**METROPOLITAN GOVERNMENT OF NASHVILLE AND DAVIDSON COUNTY**

**STAFF RECOMMENDATION**  
**1701 Russell Street**  
**October 16, 2013**

**Application:** New construction – outbuilding  
**District:** Lockeland Springs-East End Neighborhood Conservation Zoning Overlay  
**Council District:** 06  
**Map and Parcel Number:** 08314006200  
**Applicant:** David Baird, Architect  
**Project Lead:** Melissa Baldock, melissa.baldock@nashville.gov

Date: 9/19/2013  
BUILDING ELEVATIONS

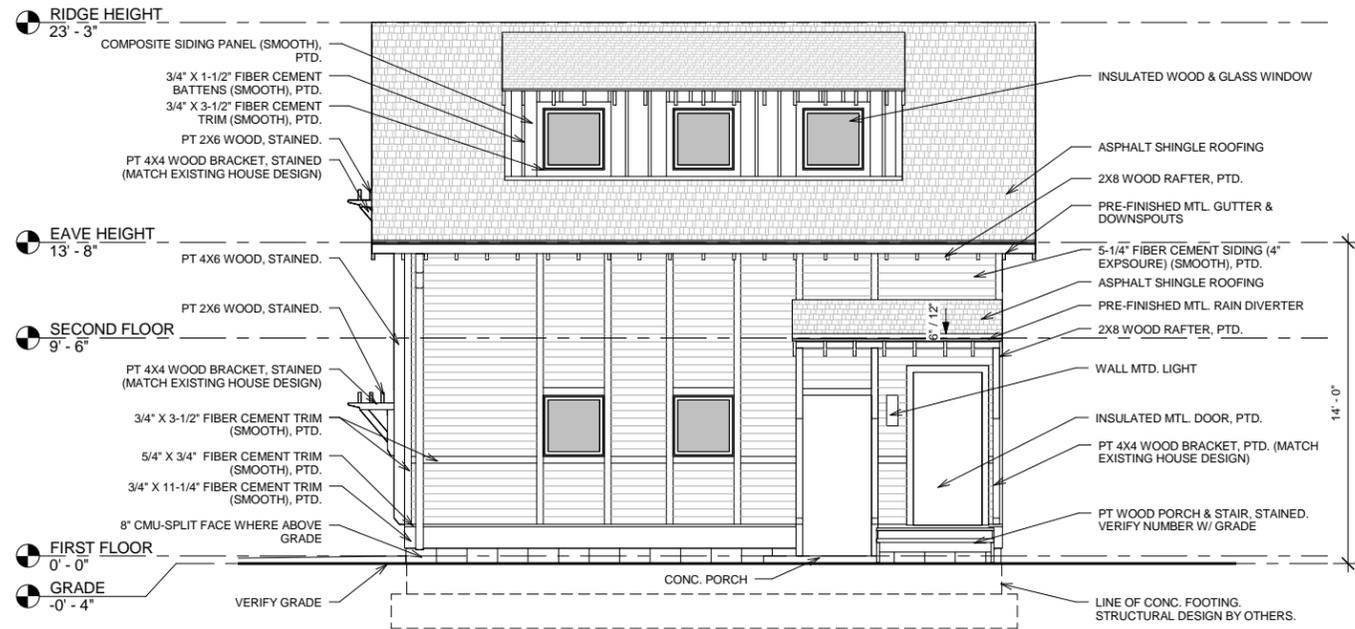
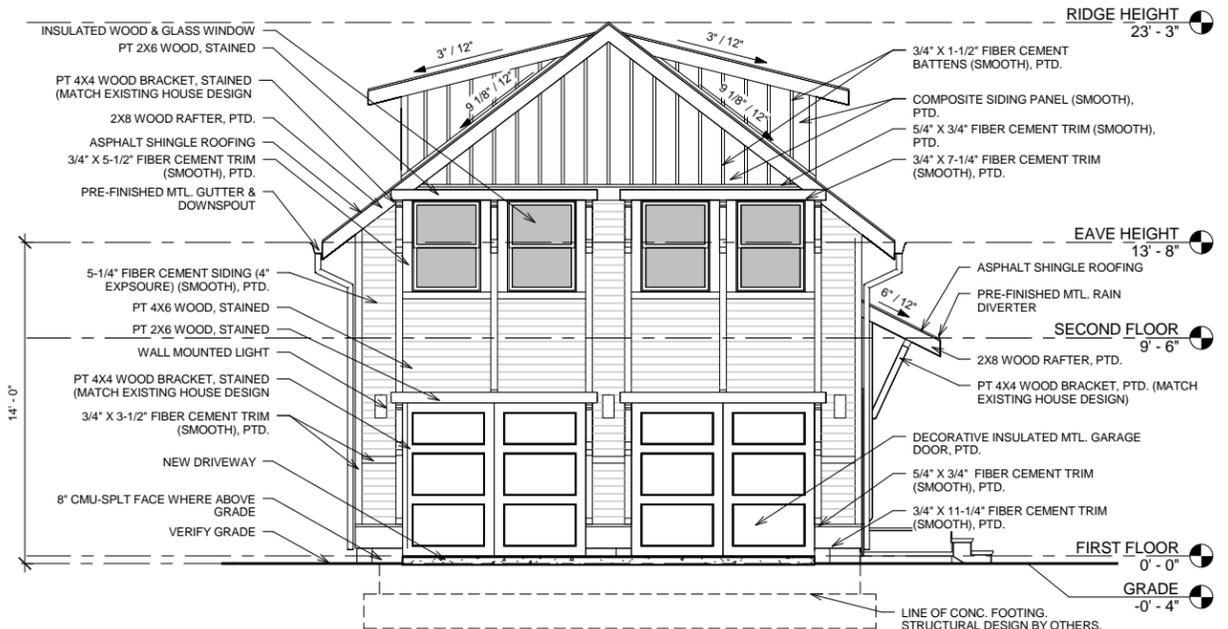
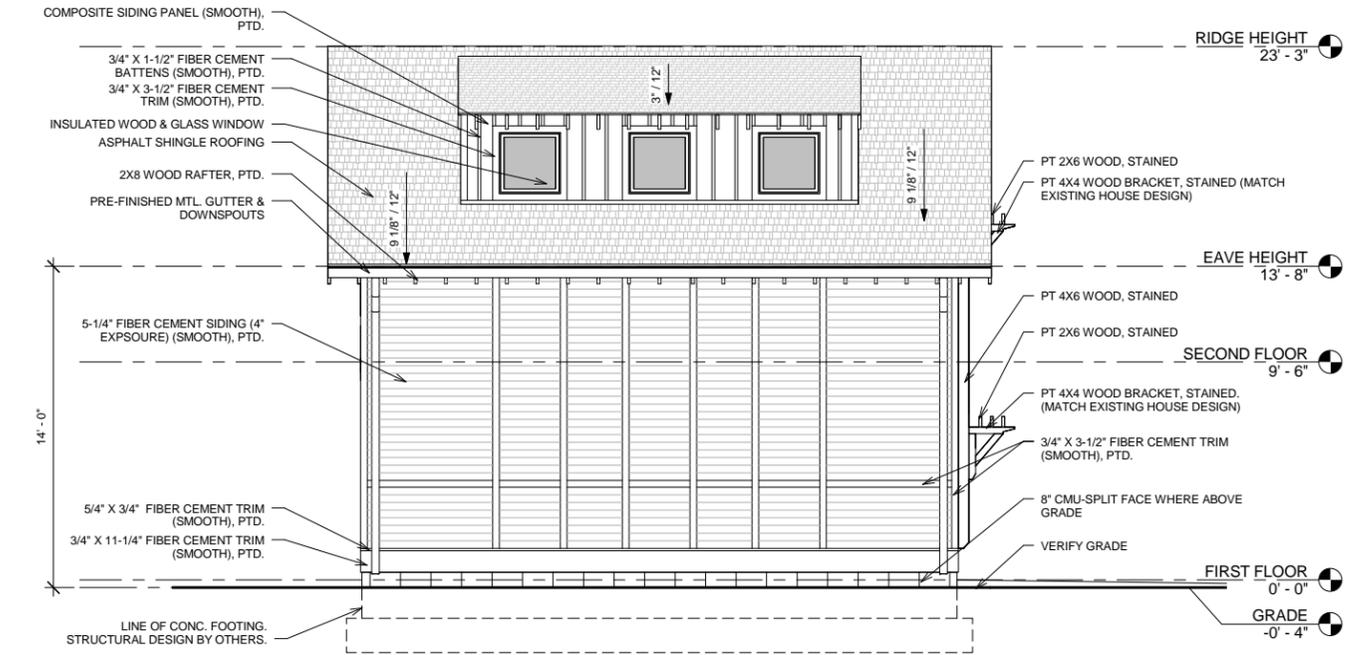
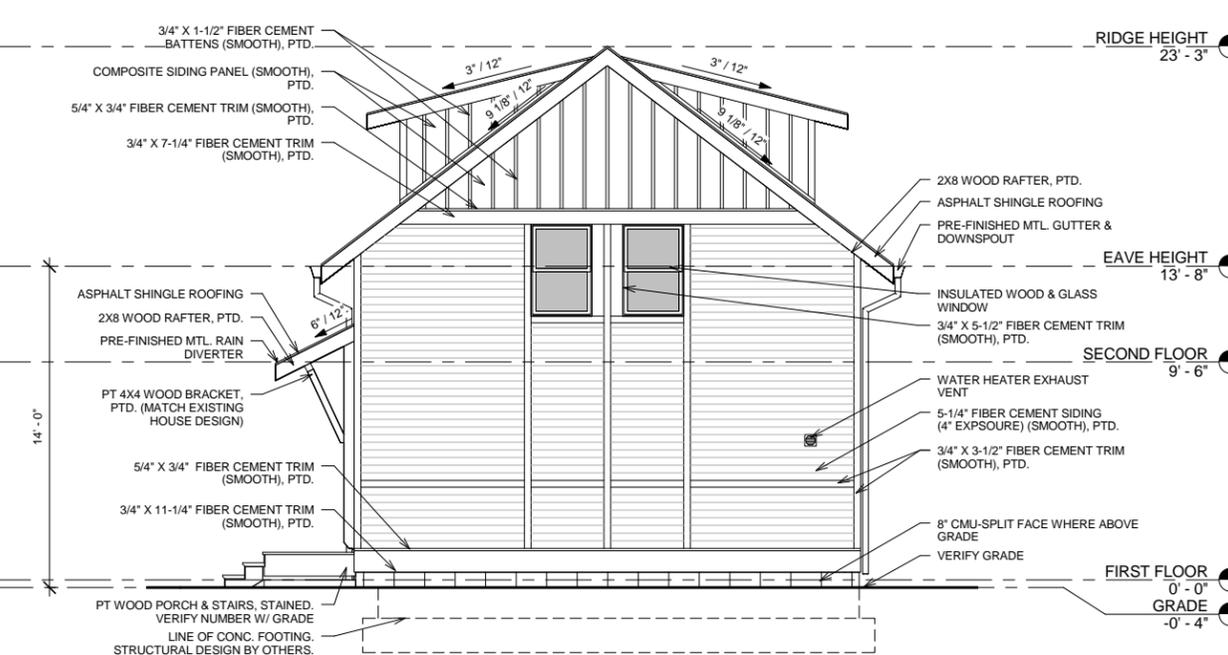
Height Scale: The primary structure on the lot is two stories, with an eave height of approximately twenty-two feet (22') and a ridge height of approximately thirty feet (30'). It has a foot print of approximately one thousand, seven hundred and fifty square feet (1750 sq. ft.). The proposed two-story accessory structure will be subordinate to the primary structure in height and scale. It will have an eave height of approximately fourteen feet (14'), and a ridge height of approximately twenty-three feet, seven inches (23'7"). It will be approximately six feet, seven inches (6'7") lower in height than the primary structure. The outbuilding will be twenty-two feet (22') wide and twenty-six feet (26') deep, and will have a footprint of five hundred and seventy-two square feet (572 sq. ft.). Staff finds the height and scale of the proposed new outbuilding to meet Sections II.B.1., II.B.2., and II.B.8. of the *Lockeland Springs-East End Neighborhood Conservation Zoning Overlay: Handbook and Design Guidelines*.

Materials: The exterior materials will be smooth-faced cement-fiber siding with a four inch (4") exposure, cement-fiber board and battens, and cement fiber and wood trim. The roof will be shingle. Staff asks that it match the shingle color of the house or be approved by staff. The foundation, where above grade, will be split face concrete block. The windows will be insulated wood and glass windows, and the pedestrian door will be metal. The vehicular door will also be metal with a simple panel pattern. Staff asks to review all windows and doors prior to purchase and installation. The stoop steps and landing will be wood. Staff finds that with the staff's final approval of the shingle color and all windows and doors, the outbuilding's materials meet Section II.B.4. and II.B.8. of the *Lockeland Springs-East End Neighborhood Conservation Zoning Overlay: Handbook and Design Guidelines*.

Roofs: The existing house on the site has a hipped roof form with a slope of approximately 7/12. The primary roof of the outbuilding is a gable facing 17<sup>th</sup> Street with a slope of approximately 9/12. The outbuilding will have shed dormers that face the rear property line and the interior of the lot. The dormers will be set back two feet (2') from the wall below, and will have shed roofs with a slope of 3/12. Staff finds that the proposed roof form for the outbuilding is compatible with the primary structure and with other outbuildings within the Lockeland Springs district. Staff therefore finds that the roof forms meet Sections II.B.5. and II.B.8. of the *Lockeland Springs-East End Neighborhood Conservation Zoning Overlay: Handbook and Design Guidelines*.

Proportion and Rhythm of Openings: The two garage bays are separated so that there are two separate openings, which is appropriate for a street-facing garage. The other window and door openings are appropriate for an outbuilding. Staff finds the proportion and rhythm of openings to meet Sections II.B.7. and II.B.8. of the *Lockeland Springs-East End Neighborhood Conservation Zoning Overlay: Handbook and Design Guidelines*.

1. Staff approve the asphalt shingle color and the windows and doors.
2. The curb cut be single-lane and expand to double width inside the lot, if the site permits.
